Crown Development Application 0000005

I OBJECT wholeheartedly to the expansion of Haslar Immigration Removal Centre to increase capacity four-fold to 600 detainees. I do not think that you realise just how CLOSE our neighbouring homes are and how much this proposal will detrimentally affect our lives forever.

diagram 3 showing scale and raised platform

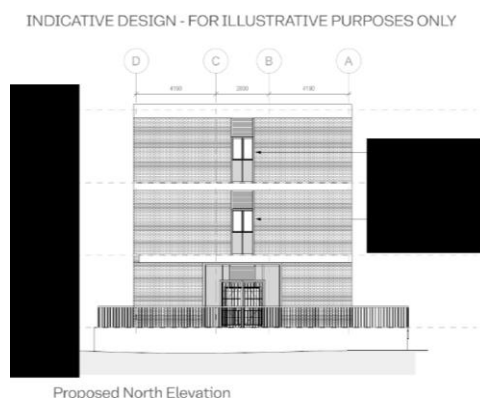
The plans state that the accommodation blocks are 3 storeys high, in fact they are 13 to 14m from ground level (12m in height raised 1.27m above ground level), which is the equivalent of 4.5 storeys (*diagram 3*). In addition, the dining hall and CASU blocks are described as single storey, but they are in fact 9m in height (the same height as a two storey home including the pitched roof) and they both have an additional floor clearly shown in the elevations (*diagram 4*). If they are single storey then they should be exactly that, not 9m high with a first floor! **This is deliberately misleading.**

Diagram 5 showing modular units for one floor of one accommodation block

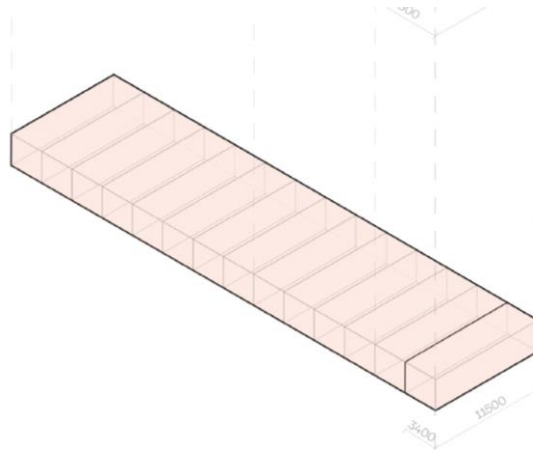
The accommodation blocks, dining hall and CASU will be ‘constructed’ of approximately 200 modular units, an absolute eyesore, not in keeping whatsoever with the surrounding area and not a design to be proud of, merely a way of cramming in as much accommodation as possible onto a restricted site as cheaply as possible, without care or consideration for the surrounding area and those who live there. (Diagram 5)

Each modular unit could be up to 16 m long and 3.5m wide, with a footprint of around 3,500 m² in phase 2 alone, all built on playing fields - **A GREENFIELD SITE!**

Photo 2 showing contractor parking both sides of road and over dropped kerbs obscuring visibility from drives.

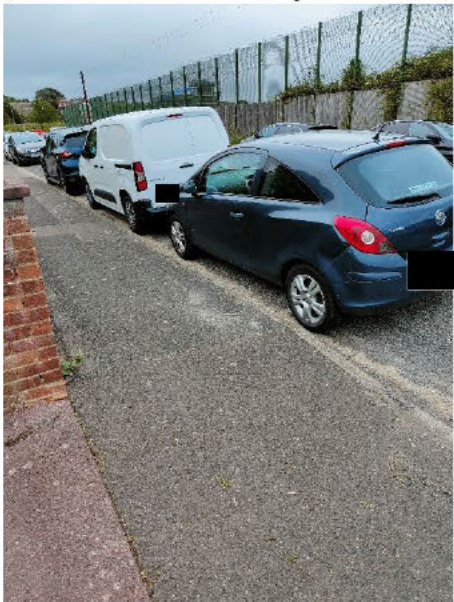
Even with the sea wall carpark, human nature being what it is means that staff will aim to park as close as possible to their place of work which, in this case, is the surrounding **residential roads**. Therefore, creating a multitude of issues including noise, air pollution, blocking drives and junctions, car alarms going off, antisocial behaviour, local people being prevented from their own visitors and contractors being able to park etc. Or roads will once again be flooded with unwanted vehicles causing unending problems (we have suffered for a year from contractor parking – photo 2 and 3

Adequate off-road parking MUST be provided and ENFORCED to completely cater for this level of staffing without impacting on the local roads.
